Site Specific Management Plan 007 - Waikanae River
MacKays to Peka Peka Expressway
M2PP-121-D-MPL-0007

SITE SPECIFIC MANAGEMENT PLAN - WAIKANAE RIVER AREA [SSMP 7 - SECTOR 470]

Appendix 2: CONSULTATION, FEEDBACK AND RESPONSES
Site Specific Management Plan 007 - Waikanae River
MacKays to Peka Peka Expressway
M2PP-121-D-MPL-0007

KCDC REVIEWERS COMMENTS: JW=Julia Williams- Landscape Architect; DP = Deyana Popova-Urban Designer; SK=Stu Kilmister-CWB Planner; SM= Shona Myers-ecologist – documented and meeting notes responses

Title: SSMP 7 - SHEET 2 MASTERPLAN

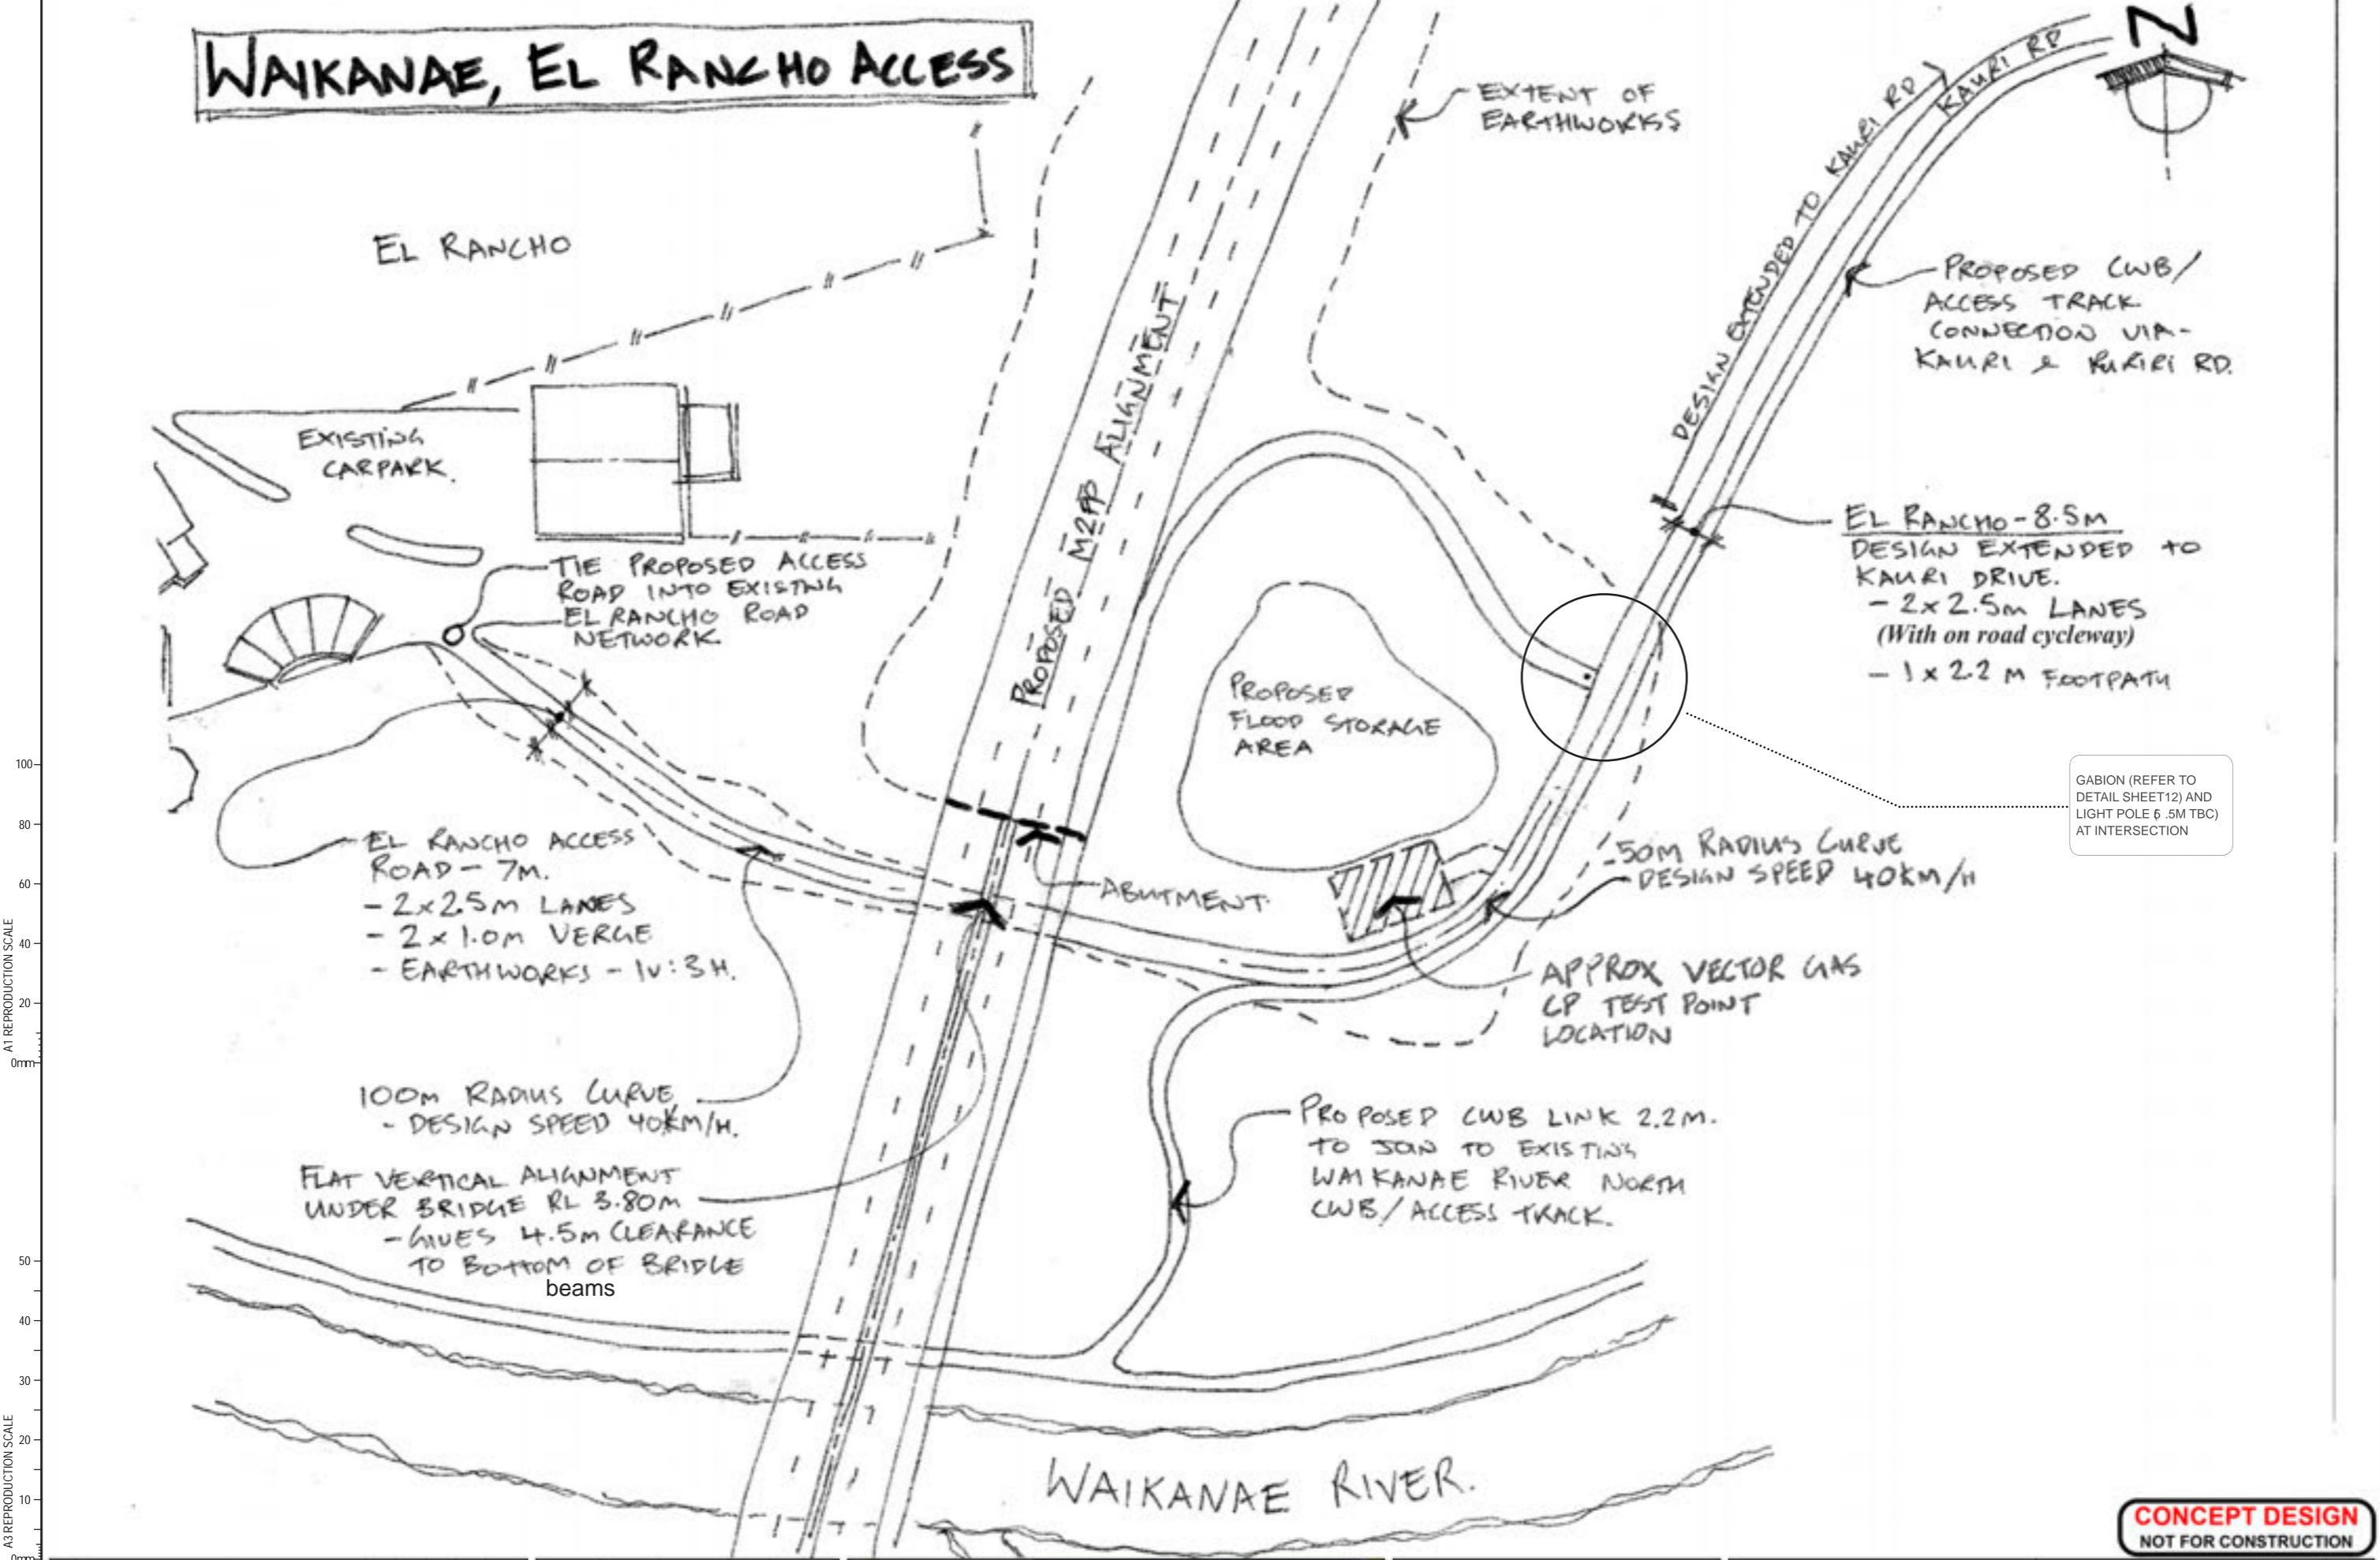
SHEET 2 - Master Plan	M2PP-121-D-DWG-8101	Revision/Update	D	Design change- El Rancho access arrangement- Removal of vehicle access under the Waikanae Expressway bridge- Supersedes all other plans showing Kauri road/El Rancho access in the SSMP	KCDC		3-5-16
SSMP 7 - SHEET 16 - CWB sign types	M2PP-121-D-DWG-8701	Revision/Update	D	Signs updated to include horse symbol - All CWB signs to be updated as per this sheet	KCDC		3-5-16
SSMP 7 - SHEET 24 Type 1 CWB entrance	M2PP-121-D-DWG-8802	New Sheet added	A	CWB entrance structures Type 1 - design change to precast units. To replace 'gabions' on sheet 12	KCDC		3-5-16
SSMP 7 - SHEET 25 Te Atiawa Column Design	M2PP-121-D-DWG-8803	New Sheet added	A	Page added to illustrate Te Atiawa design to be applied to bridge columns (sand blasted etching)	KCDC		3-5-16
SSMP 7 - SHEET 26 Kauri Road End Detail	M2PP-121-D-DWG-8304	New Sheet added	A	Page added to show intersection between Kauri Rd and CWB Link	KCDC		3-5-16

Condition Reference	Condition Detail	Reviewer/ commenter	KCDC Reviewer's comment	reference in SSMP	Management Plan Author's response
	LMP principles, methodologies and procedures (where appropriate)	JW	Requires Final specification to verify	Appendix 4	Draft Landscape Specification supplied undergoing internal review and once signed off final version will be provided. .
	Landscape Conditions Condition DC57(f): Maintenance standards;	JW	Requires Final specification to verify	Appendix 4	Draft Landscape Specification supplied undergoing internal review and once signed off final version will be provided
	Urban design Conditions DC 59A g) ii)	JW	The CBW should be 3.0m wide between Waikanae Bridge and Otaihanga Road. Expect to see the Masterplan show that the CWB increases from 2.5m (on bridge) to 3.0m south of bridge at the point where it intersects with 2.2m link that runs down to river. Notation on plan should confirm this.	SHEET 2

DC 59A f) i)	JW	Lighting pole at intersection of the CWB and El Rancho Road. Confirm height of pole on plans.		Notation added re location of lighting pole; proposed height of lighting pole is 5.5m but this is yet to be confirmed.
	Consultation	JW	Consultation not received form Takamore Trust or Te Ati Awa ki Whakarongotai needs to be completed		An initial meeting was held with Ben Ngaia, Takamore Trust on 18th September 2013; a copy of the SSMP provided for Ben to take away and discuss with the Trustees.

DC.59(a)	Matters to be included in an SSUDP		Concern raised about the lack of permeability to the outer Waikanae river bridge barrier – is it possible to modify the barrier to allow better visibility out to river?	SHEET 2	Consideration has been given to the edge barrier and this is designed to be consistent with the other side of the bridge so the bridge form appears consistent (as per the ULDF principle 5.8.1). Most people will still see over the barrier as it is solid to 1.1m high (about waist height for an adult) and then has a handrail on top making it 1.4m high. There is a gap between the solid and the top rail.
DC.59(a)	Matters to be included in an SSUDP		Concern raised about the height and proximity of proposed vegetation to the CWB	General	Planting will be low adjacent to the CWB – either grass or low so it can be seen over and taller vegetation does not obscure sight lines or snag cyclists

Title: SSMP 7 - SHEET 6 LONG SECTION

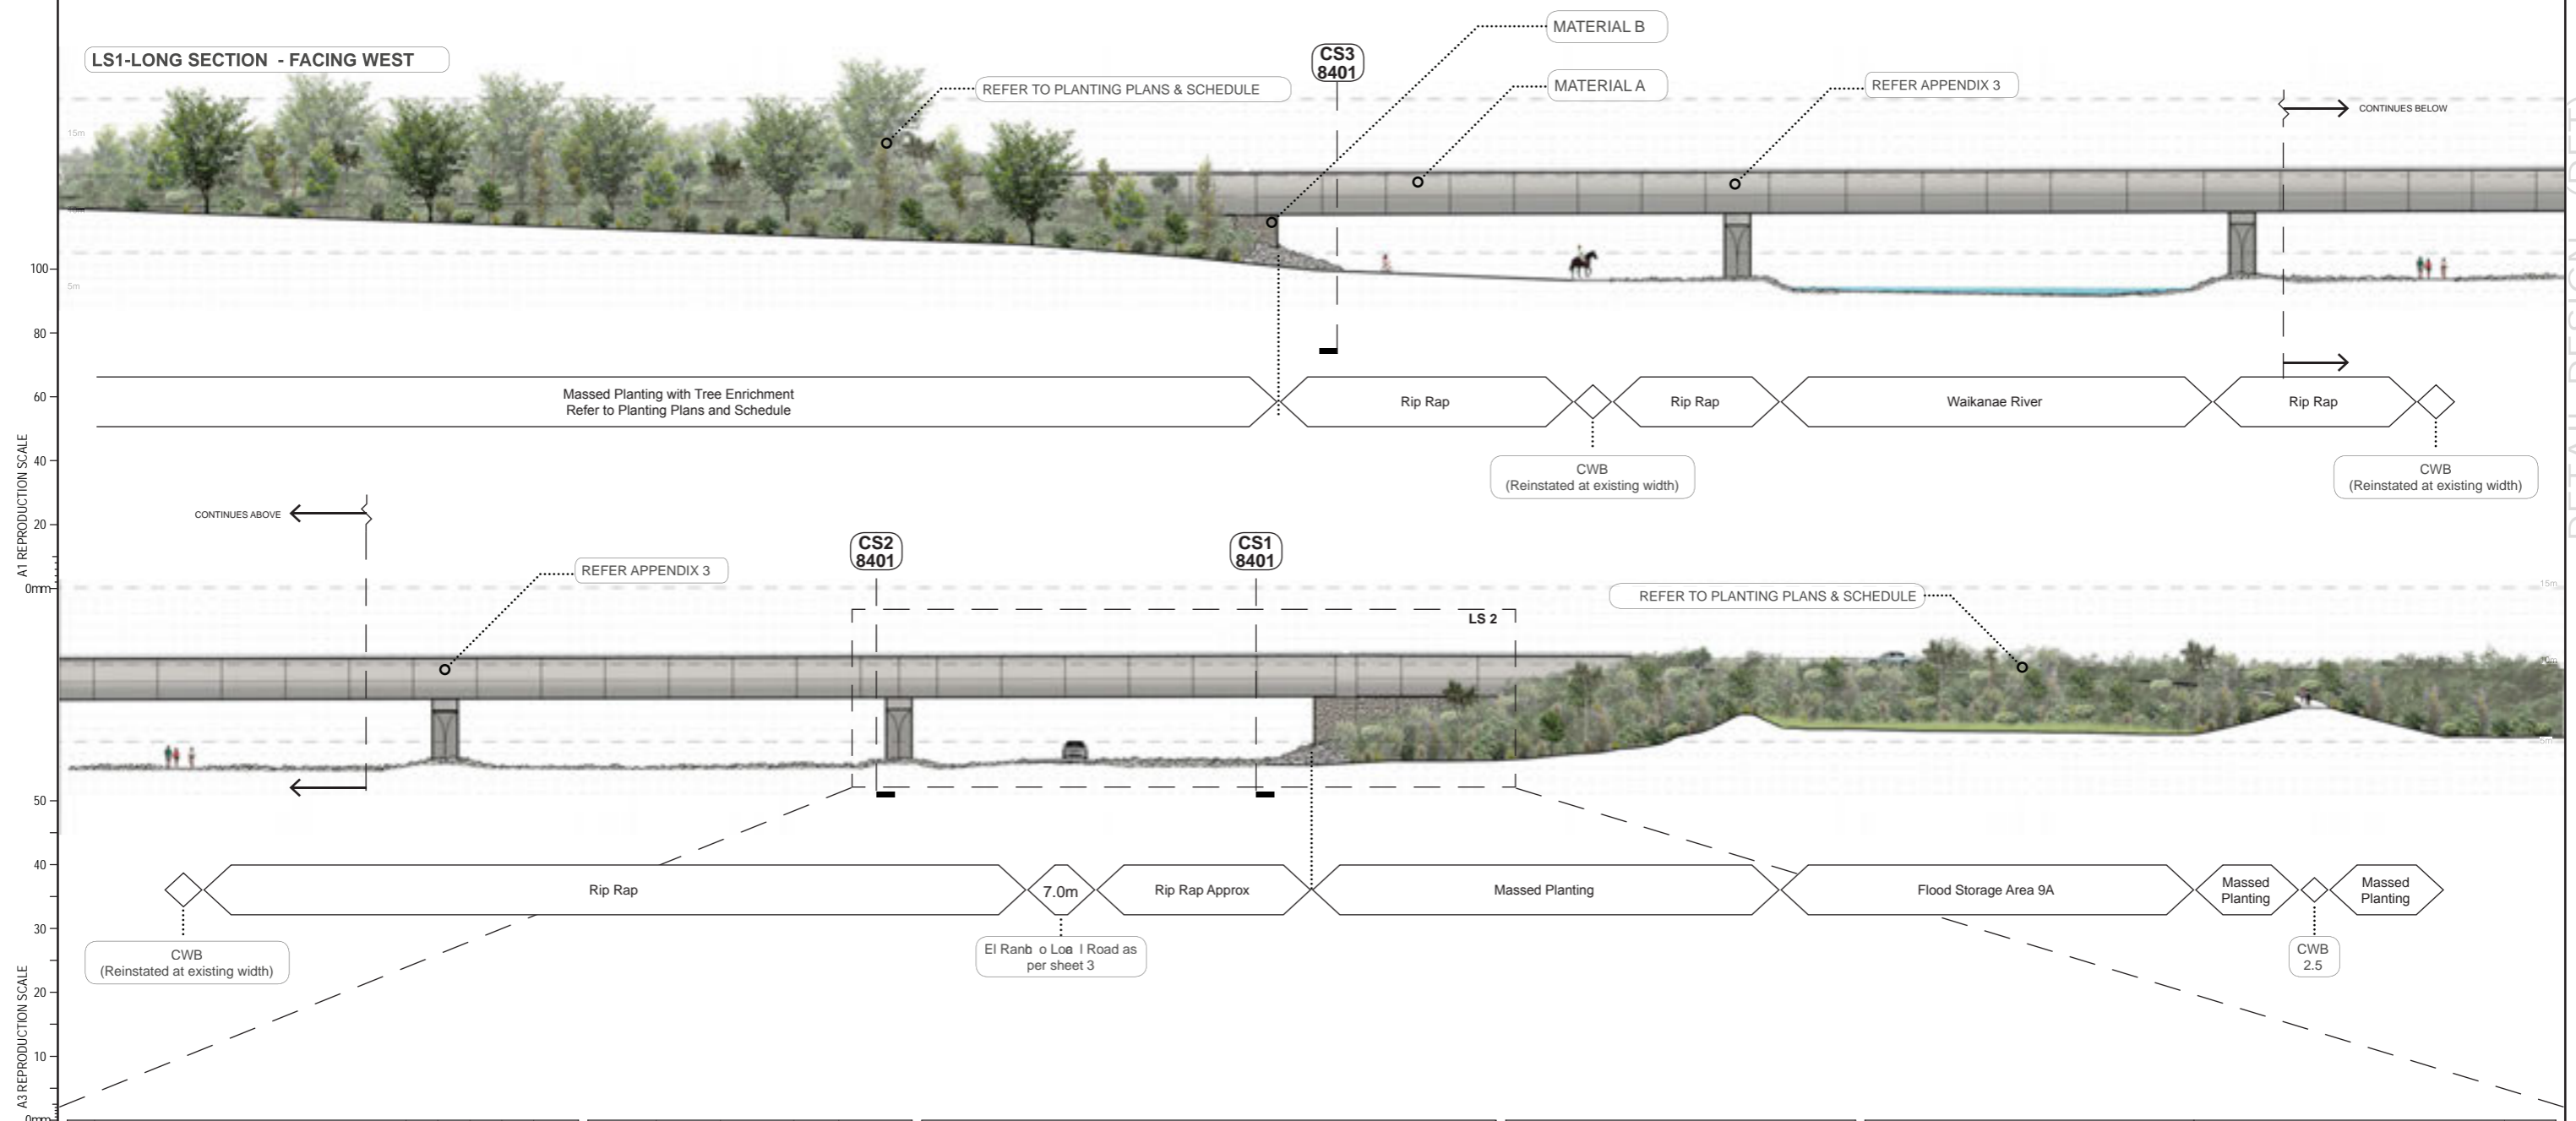
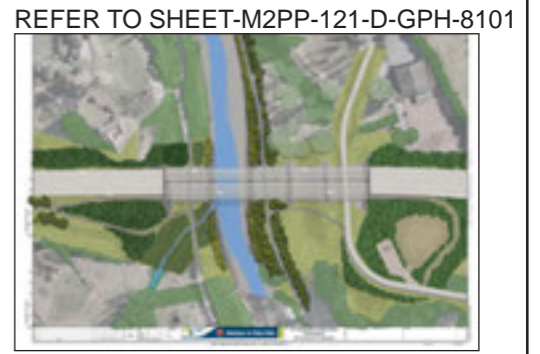
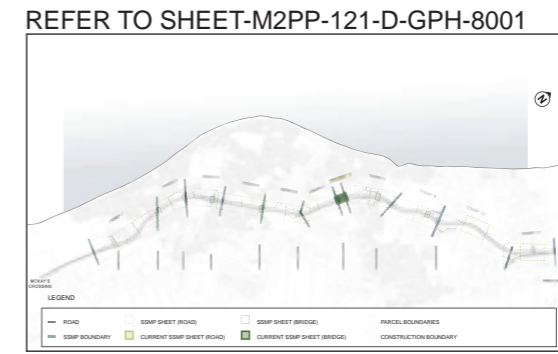
Informal notes:	JW	Sheet 6 Long Section - Notate 2.2m CWB on El Rancho Road cross section		Has been amended.
	Informal notes:	JW	<ul style="list-style-type: none"> • Sheet 7 • top left corner on Cross section 1 – layers are been mixed and plan has whited out area over it 		Printing error has been corrected.
	Informal notes:	JW	Sheet 19 Planting sections and details introduces ribbonwood and cabbage trees to riparian planting but they have not been transferred to Sheet 20 Planting Schedule		Plant schedule has been amended accordingly.
